SUPPLEMENTAL SITE CERTIFICATION APPLICATION

ORLANDO UTILITIES COMMISSION CURTIS H. STANTON ENERGY CENTER UNIT B IGCC PROJECT

SUFFICIENCY RESPONSES

A. FLORIDA DEPARTMENT OF ENVIRONMENTAL PROTECTION
Memorandum from Al Linero (FDEP) to Mike Halpin (FDEP),
Dated April 5, 2006

Figure 6-2
Effect of Coal Quality on Heat Rate and Capital Cost

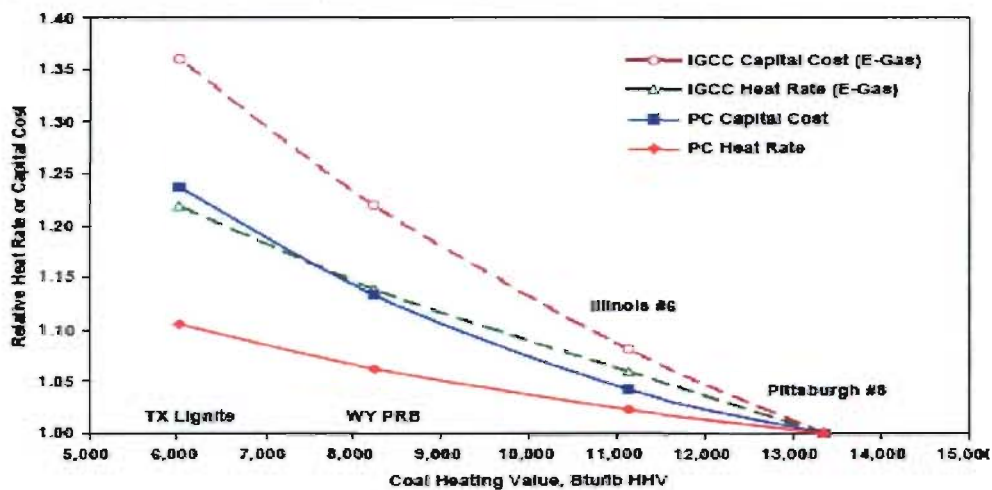
FDEP-2—According to available information, the pilot-scale KBR Transport Gasifier was tested at Wilsonville for air-blown and for oxygen-blown configurations. According to the SCA, an air-blown design will be demonstrated. Please provide the justification for selection of the air-blown variant and its impacts on emissions and emission control options. Include any information related to requirement, if any, for an air-blown version versus an oxygen-blown version to receive the DOE support. In the air-blown variations, the coal is introduced into the gasifier with compressed air. In the oxygen-blown variations, an air separation unit (ASU) is necessary to separate at-

Stanton Unit B will utilize a sub-bituminous Powder River Basin (PRB) coal—a low-rank, high-moisture, high-ash coal. Because low-rank, high-moisture, and high-ash coals comprise approximately half the proven coal reserves in the United States and the world, utilization of these coals for power generation is an essential component of United States energy policy. Currently employed integrated gasification combined-cycle (IGCC) technologies use high-rank fuels and are not competitive economically for operation with low-rank fuels. A recent Electric Power Research Institute (EPRI) report discussed the effect of coal quality on coal plant economic feasibility and published the figure below showing the impact of coal rank on the relative heat rates and capital cost of pulverized coal (PC) plants and IGCC plants. The report stated, “This illustrates the widening gap for lower rank coals, particularly for slurry-fed gasifiers, such as ChevronTexaco (now

owned by GE) or ConocoPhillips. This reinforces the need for development of improved gasifiers, such as the KBR Transport Gasifier, for low-rank coals.”

Although some proposed future IGCC plants include the technical flexibility to process sub-bituminous coals, economic estimates using these technologies with sub-bituminous coal compare unfavorably to bituminous coal. While all gasifiers can process low-rank sub-bituminous coals, not all gasifiers can perform as well economically as the air-blown Transport Gasifier. Economic studies performed by EPRI and by SCS in conjunction with DOE, indicate that the Transport Gasifier is an economically promising option.

Effect of Ammonium Bisulfate Formation on Plant Availability

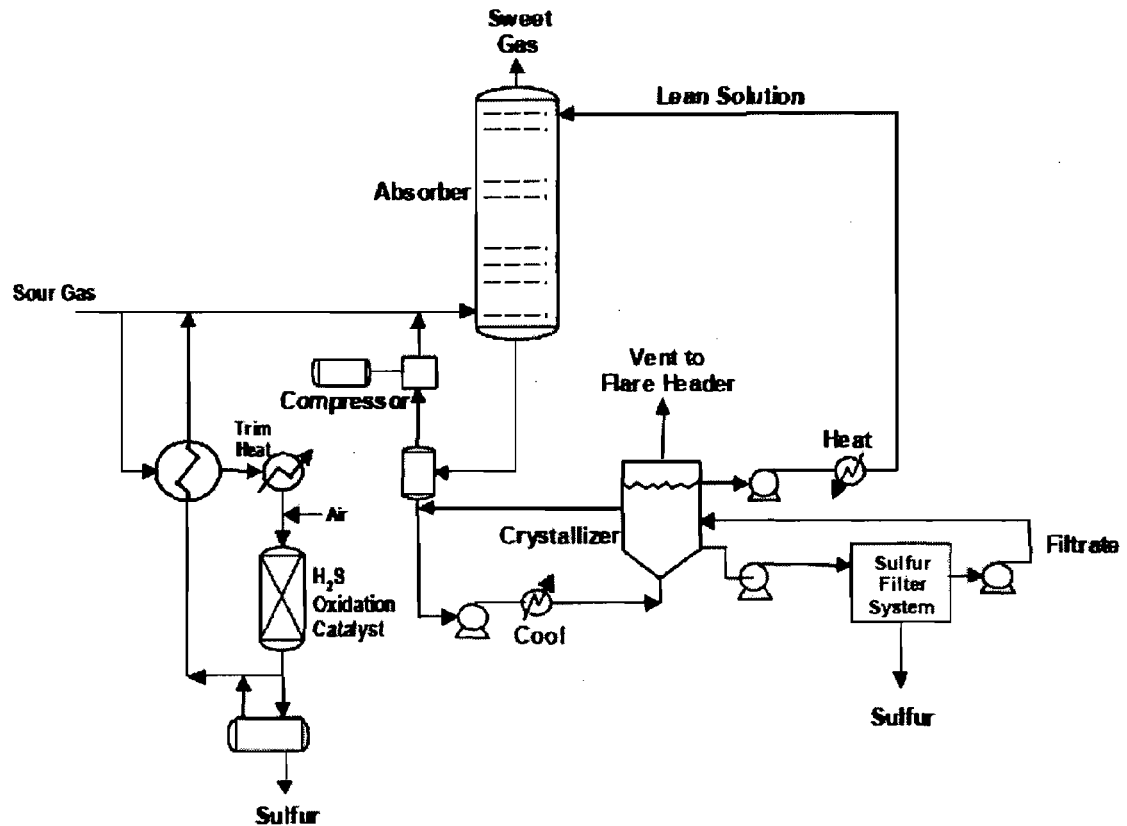
FDEP-12—Please provide an estimate on the breakpoint when sulfur in the syngas actually becomes a problem. On the one hand, the claim is made that virtually any sulfur presents a problem. On the other hand, GE seems to believe that 0.01 lb SO₂/mmBtu is acceptable for its oxygen-blown gasifier design while achieving very low NO_x emissions. Note that with the great head-start from low sulfur PRB coal this issue will not be as difficult as it is for high sulfur Eastern coal IGCC plants for which GE developed.

Any amount of sulfur in the CT exhaust gas creates the potential for ammonium salt formation and deposition and/or acid corrosion in the heat recovery steam generator (HRSG). Problems such as these that lead to lower reliability, forced outages, or increased maintenance outages are unacceptable for a planned base-loaded unit such as Stanton Unit B. Even at the low levels that have been proposed for Stanton Unit B, sulfur

A study performed by GE and presented by EPRI predicted the effects of ammonium bisulfate (ABS) formation on plant forced outage rates. The chart below shows the predicted forced outages caused by ABS as a function of SO_x concentration in the turbine exhaust gas. It is important to note that the chart reflects only 5-percent oxidation of SO₂ to sulfur trioxide (SO₃), which is an expected reaction in the CT. Therefore, the assumed SO_x concentration only contains 5 percent SO₃, the precursor to ammonium salts and acid gas. (Wabash River Generating Plant has reported 9-percent oxidation of SO₂.)

However, further oxidation of SO₂, which would be expected if an oxidation catalyst is used, would significantly exacerbate the problem of acid gas and ABS formation. The scale at the top of the chart shows the calculated SO₃ concentration based on 5-percent oxidation. If using an oxidation catalyst, 50- to 90-percent oxidation of SO₂ would be expected based on vendor information and EPRI reports. Based on the GE study, for a syngas sulfur concentration at the lowest theoretically achievable value, 50-percent oxidation could potentially cause seven unplanned shutdowns per year.

Until actual operational experience is gained, the precise amount of allowable syngas sulfur content is unknown. Based on the best information available, the use of an oxidation catalyst is not feasible.

FIGURE 3.5-3.
DETAILED UNIT B WATER BALANCE DIAGRAM

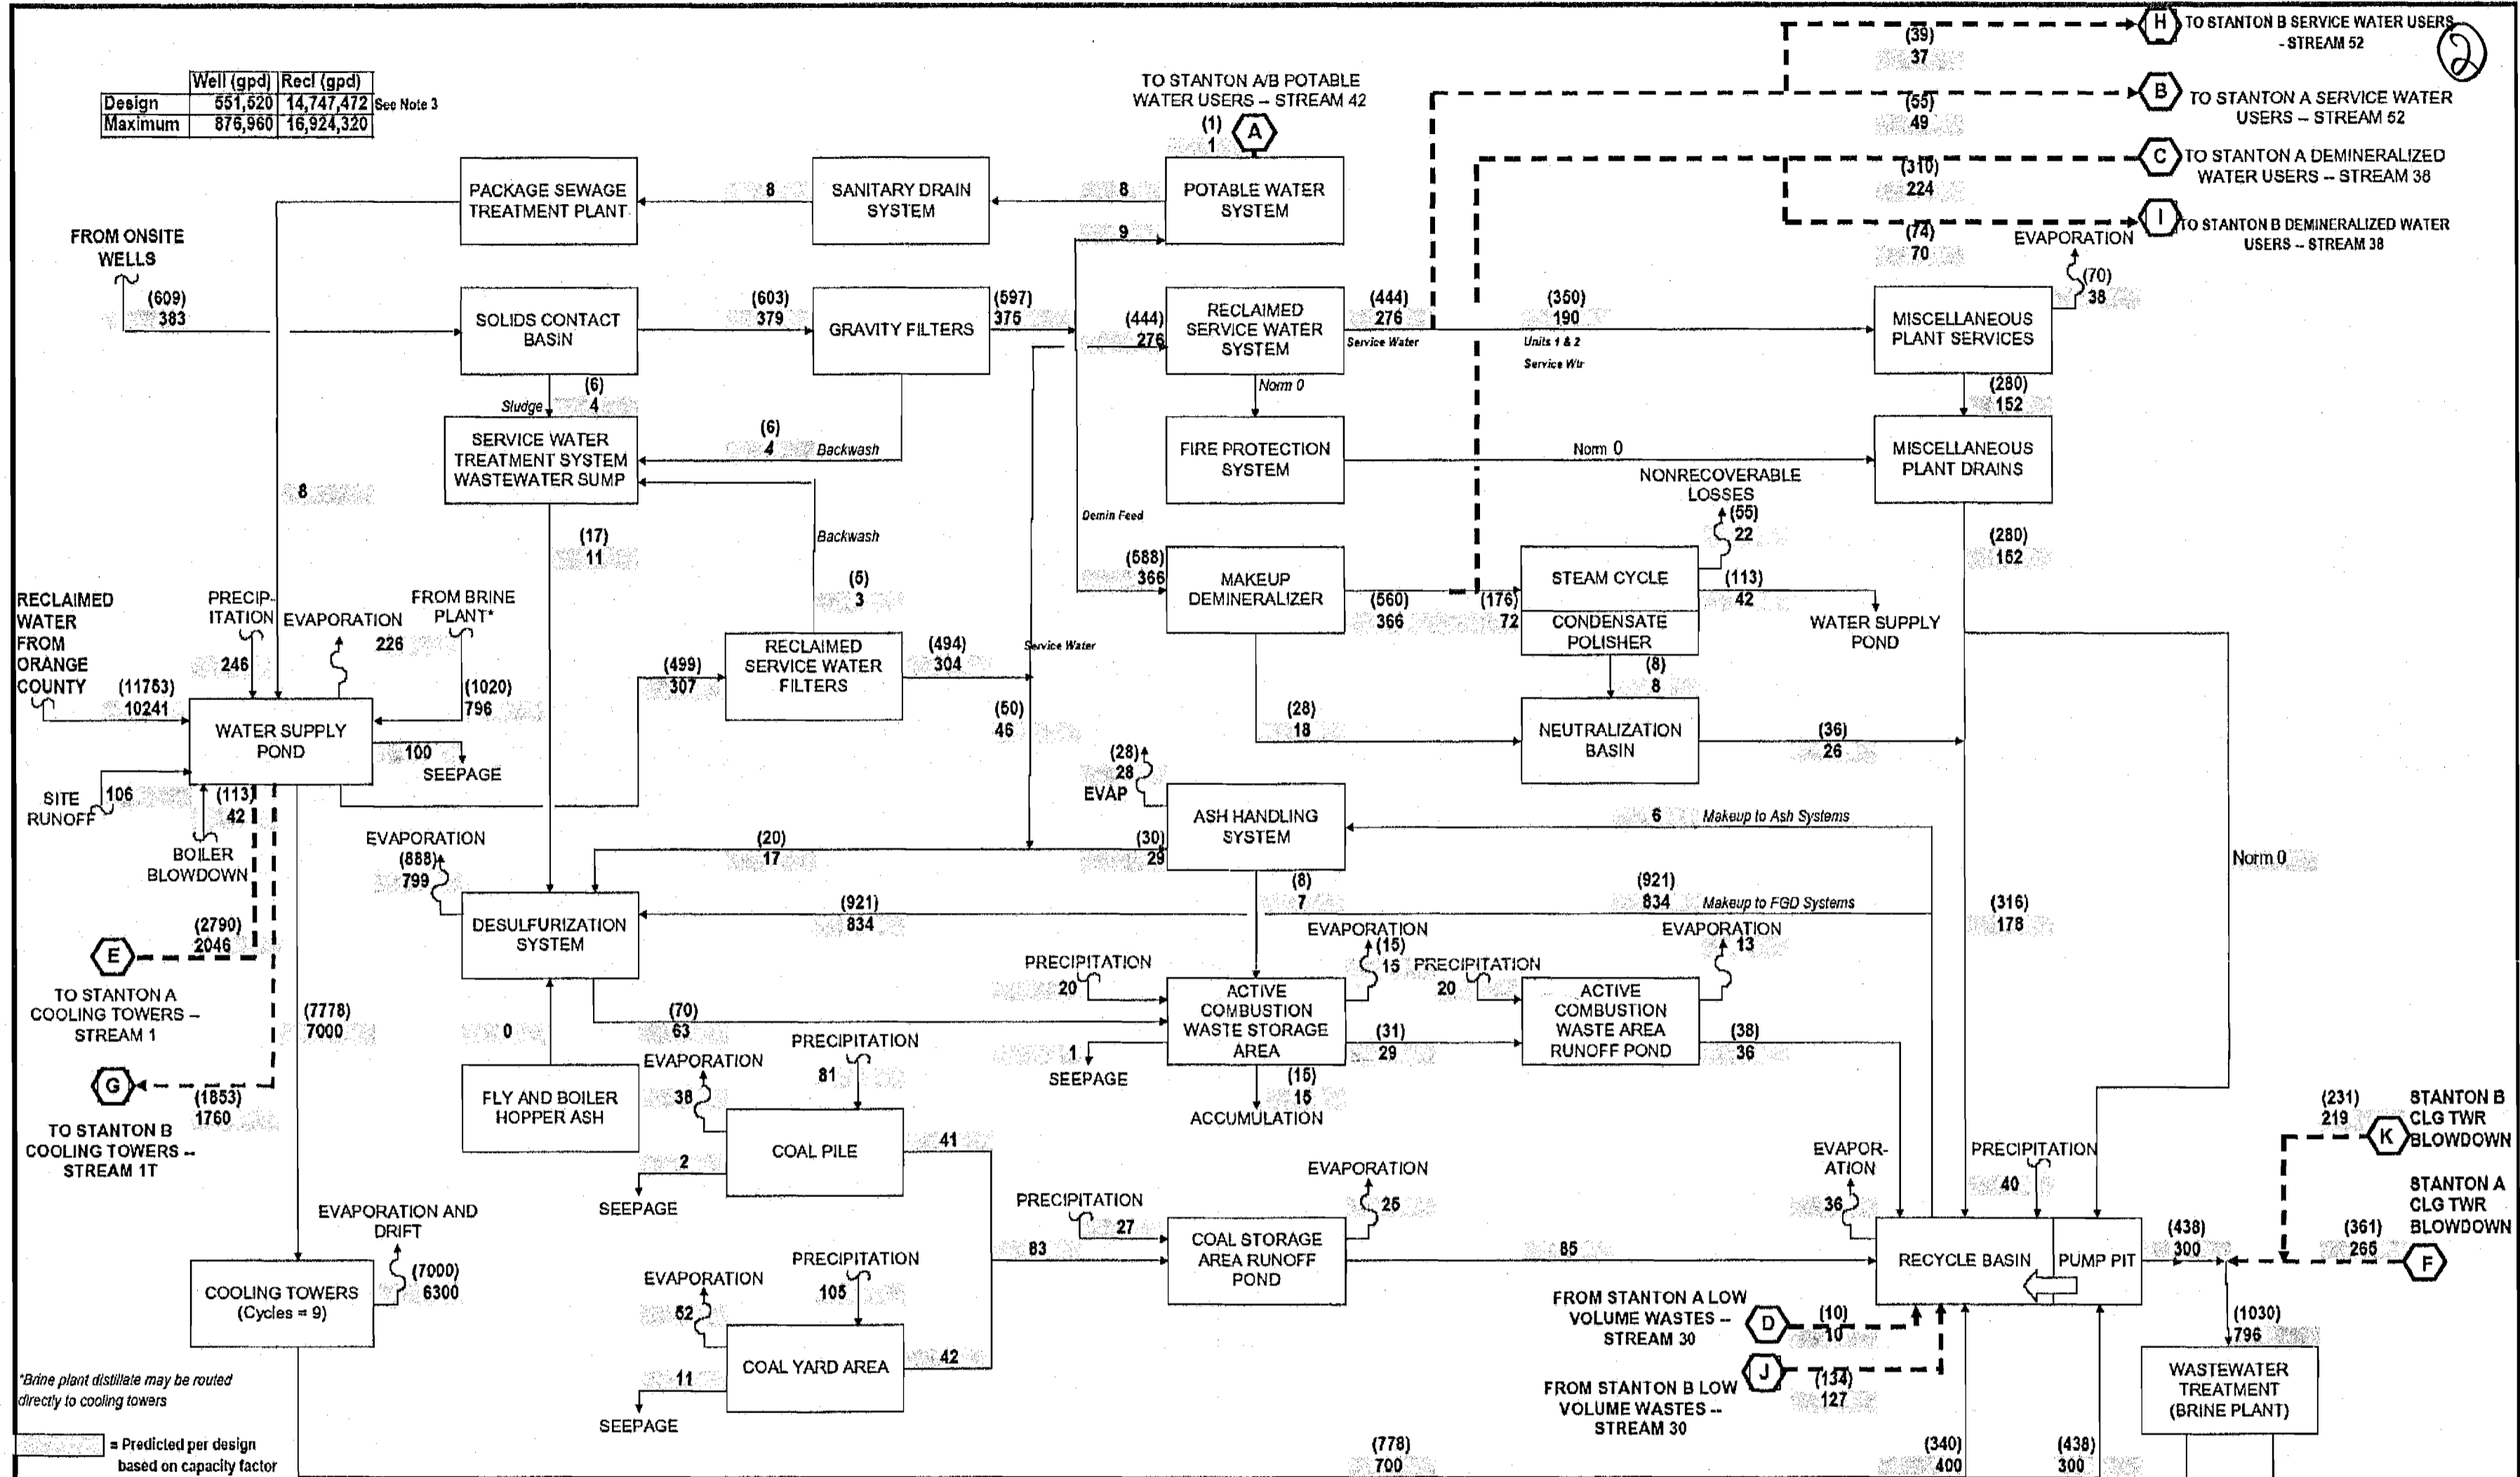
- **Figure 3.5-1 indicates a (113) 42 gpm new wastewater stream from steam cycle condensate polisher to water supply pond and a (1020) 798 gpm wastewater stream from the Wastewater Treatment (Brine Plant) to the Make Up pond.**
- **Figure 3.5-2 indicates a wastewater stream (30) to the wastewater recycle basin.**
- **Are these new flow numbers for the addition of Unit B ONLY?**
- **Are they combined flow numbers from Existing Facilities and new Unit B?**
- **Are the existing wastewater streams characterization affected by the addition of Unit B and Coal gasification additions?**

Enlarged versions of the referenced sketches are attached. Figure 3.5-1 is an overall Stanton Energy Center water balance, including the new Unit B. Figure 3.5-2 is a simplified water balance for Unit B only. The existing wastewater streams characterization will not be affected by the addition of Unit B.
